**Seattle
Design
Commission**

**APPROVED
MINUTES OF THE MEETING
2 October 2003**

Projects Reviewed

Homer Harris Park
SR 520 Project
Design Commission 35th Anniversary Project
I-5 Open Space
Montlake Library
Belltown Community Center

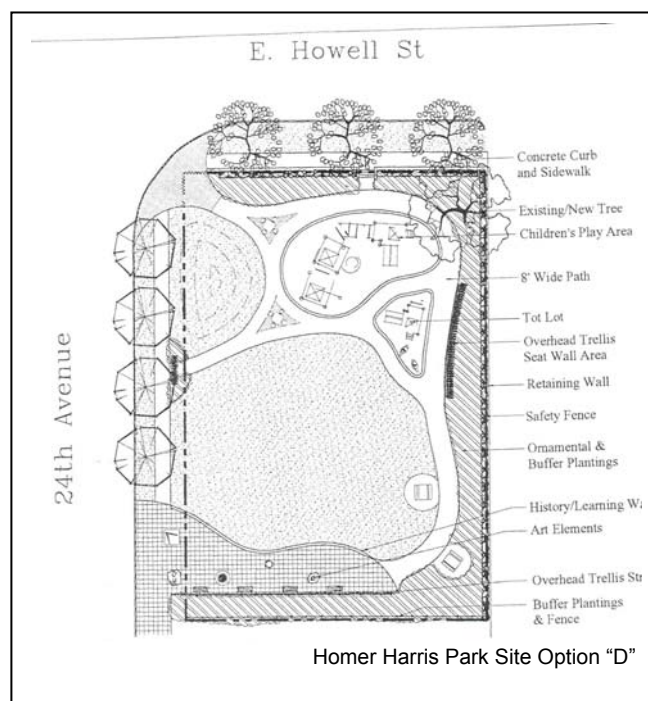
- The Design Commission feels that the design is moving in the right direction by recognizing that this is not a view park and encourages the team to move further in that direction possibly by thinking of it as more of an inward looking park;

- notes that the focus of the park is unclear so that it feels like a kit of parts rather than a strong design statement;
- is not convinced by the physical forms that have been presented that the vision of celebration and community building is assured, especially to users who may not already be admirers of Dr. Harris;

- recommends that the team create the design principles focusing on elements that can be achieved through design, rather than text;
- encourages the team to develop a stronger, more inspired concept, to better express the creation of a “warm center” for the park, and to clarify the circulation in relation to that center;

- supports the inclusion of the play area, but recommends that the team look further at how the play area reinforces the central concept of the main gathering space;

- encourages the team to develop a stronger physical reference to the adjacent William Gross property, given its existence and significance;
- would like the team to bring in the artist as part of the initial design concept, especially given the symbolic nature of this park;

- would like to see an analysis of the intersection of the ecology of the site and the human use of the park;
- supports the direction of scheme D, but not its execution;

- and does not recommend approval of concept design.

I-5 Open Space – Site Plan

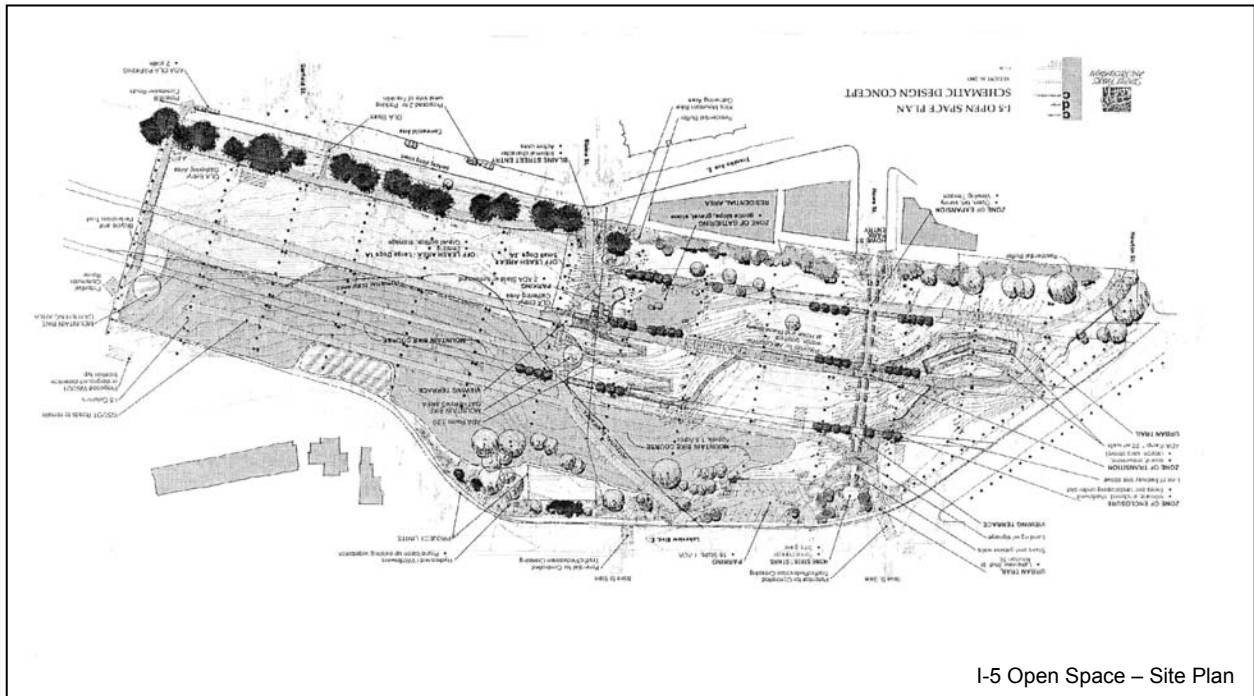
- **The Commission appreciates the attempt to create an abstraction of nature in an uncanny environment, and would like the artist's work to be better integrated into the project;**

- **urges the team to continue to work to control dust and erosion;**
- **suggests that the team consider how the design will function at different times of day;**

- **feels that the location of the functions work well in relation to the neighborhood and that the circulation including the accessible circulation works well;**

- **encourages the team to study whether a small lawn area or areas could be incorporated into the design;**
- **urges the team to look at where places to contemplate the sculptural power of the space could be inserted in the plan;**

- **is concerned about whether the vegetation envisioned with the art will actually grow;**
- **looks forward to seeing how rainwater would be incorporated into this design;**

- **feels that the dog run is a function that takes a lot of space and that the size shown is appropriate, and asks the team to continue to consider creating separate areas for small and large dogs;**

- **encourages the team to work further to develop the entries into the park;**
- **looks forward to seeing the details of the design and the specific materials that will be used; and**

- **recommends approval of schematic design.**

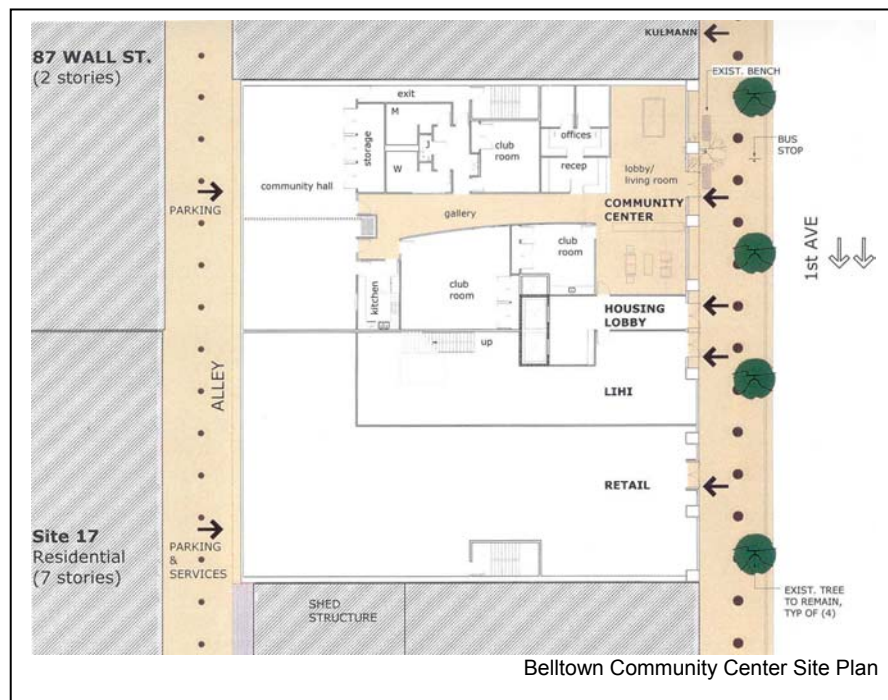
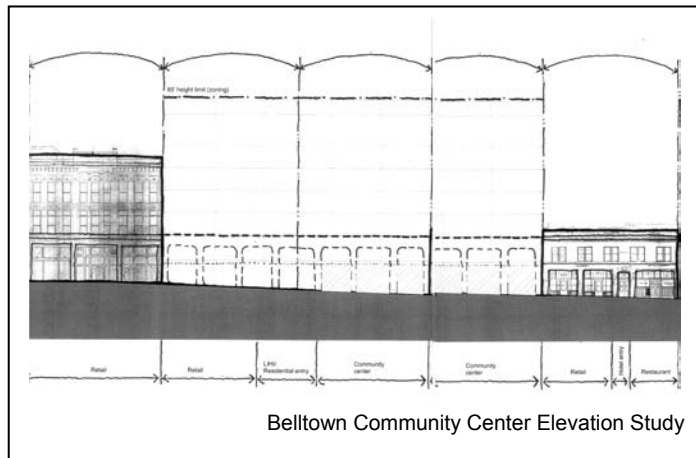
- **The Commission appreciates the care with which the team has looked at the zoning and planning regulatory environment and the community in which they are working, as well as the physical forms of the surrounding development;**

- **encourages the team to seek resolution of the zoning issue, which appears to be a legal tangle rather than an intent, and fully endorses the community center use on this site;**

- **looks forward to seeing this project in the future; and**
- **recommends approval of pre design.**

- Feels that this is an appropriate location for this kind of facility.
- Appreciates that the grade change has been used as an advantage.
- Encourages the team to continue to develop an overall identity for the project, while making the parts as distinctive as possible.

- Questions which roof level the proponents are considering developing.
 - Proponents stated that the upper roof is more likely to be developed. The lower roof may only be accessible for maintenance because of its proximity to the residences.
